- rev.a - April 2018 - position of rooflights & parking amended
- rev.b - Nov 2018 - double doors added to N elevation, light positions shown, siting of development amended as to drawing no. 08/603/25 by 600000

SITE/ROOF PLAN (superseded)

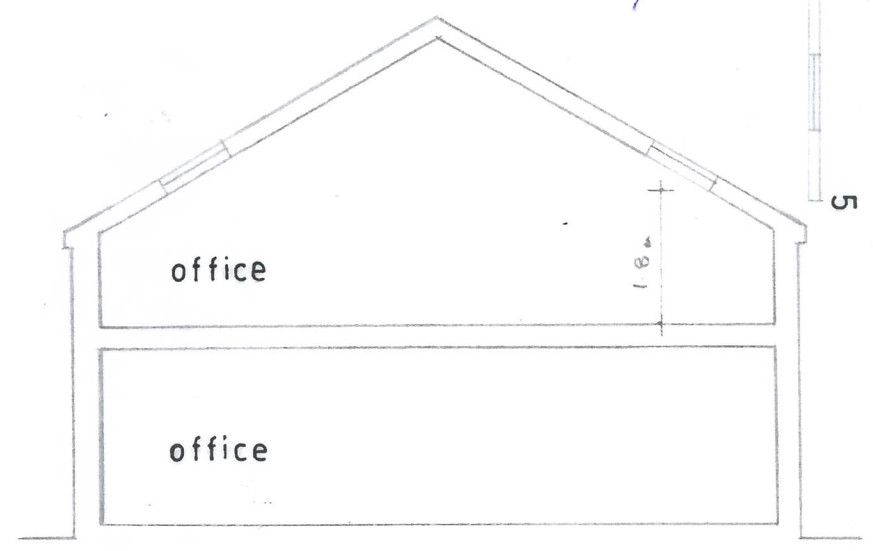
ROOF PLAN - SEE DRAWING 08/603/25a
 Changes: Building slightly repositioned
 Two parking bays added.
